RAMSEY'S PLACE SUBDIVISION

APPLICATION NUMBER 22 DATE June 5, 2003

REQUEST Subdivision

RAMSEY'S PLACE SUBDIVISION

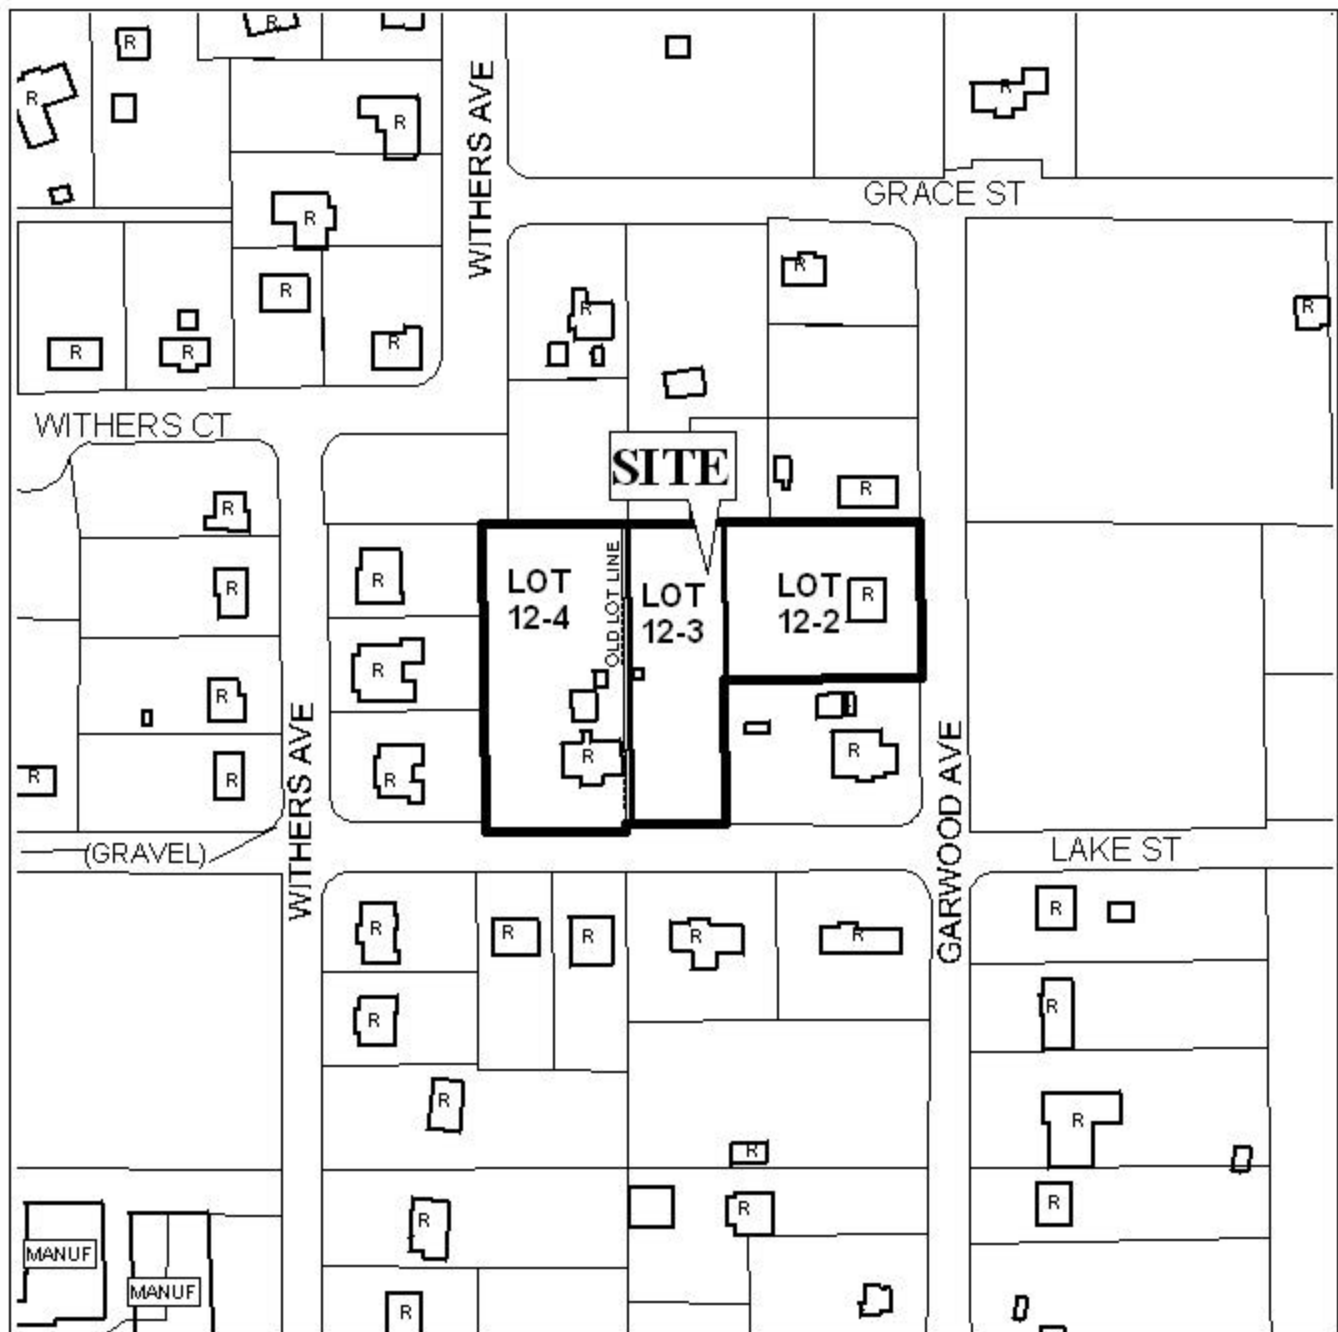
Garwood Avenue and Lake Street, both of which have an existing right-of-way of 48.5-feet, are minor streets, and as such require a 50-foot right-of-way; therefore, the dedication of sufficient right-of-way to provide 25 feet from the centerline should be required.

The plat meets the minimum requirements of the Subdivision Regulations and is recommended for Tentative Approval subject to the following conditions: 1) the dedication of sufficient right-of-way to provide 25-feet from the centerline of Garwood Avenue and Lake Street.
